TDPL: MIL-PRF-51191

NOMEN: Heater, Air, Electrical, Filter Unit, M3

The following engineering exceptions apply to this TDPL, and shall be incorporated into solicitations/contracts for the above listed PRON(s):

NOTICE OF REVISION (NOR)		1. DATE (YY/MM/DD) 03/02/24	Form Approved OMB No. 0704-0188
THIS REVISION DESCRIBED BELOW HAS BEEN AUTHORIZED FOR THE DOCUMENT LISTED			
Public reporting burden for this collection of information is estimated to average 2 hours per response, including the time for reviewing instructions, searching existing data sources, gathering and maintaining the data needed, and completing and reviewing the collection of information. Send comments regarding this burden estimate or any other aspect of this collection of information, including suggestions for reducing this burden, to Department of Defense, Washington Headquarters Services, Directorate for Information Operations and Reports, 1215 Jefferson Davis Highway, Suite 1204, Arlington, VA 22202-4302, and to the Office of Management and Budget, Paperwork Reduction Project (0704-0188), Washington, DC 20503.		2. PROCURING ACTIVITY NO. 362-0002

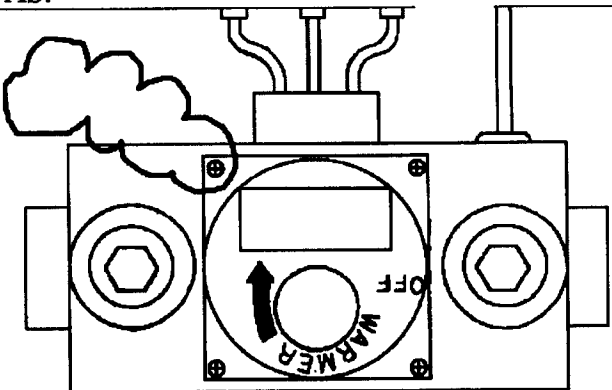
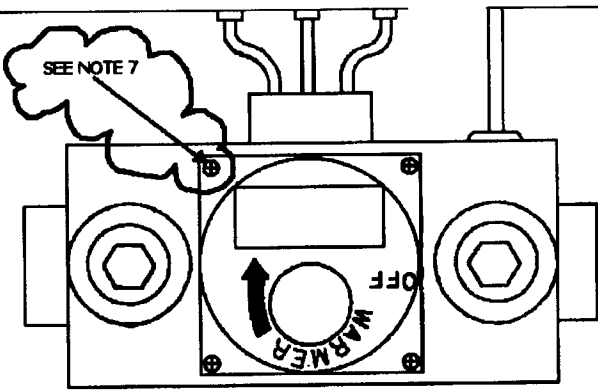
NOTICE OF REVISION (NOR) CONTINUATION SHEET		1. DATE (YY/MM/DD) 03/02/24	NOR CONTINUATION SHEET 2 OF 2						
ORIGINATOR NAME AND ADDRESS Guy N. Cabell AMSSB-RSO-CPT (RI) Rock Island, IL 61299-7390		NOR NO. 362-0002-001 <hr/> DOCUMENT NO. 5-19-1782 <hr/> ECP NO. 362-0002							
DESCRIPTION OF REVISION 3. Zone E-6, E-7. Pictorial, revise as follows:									
WAS:		IS:
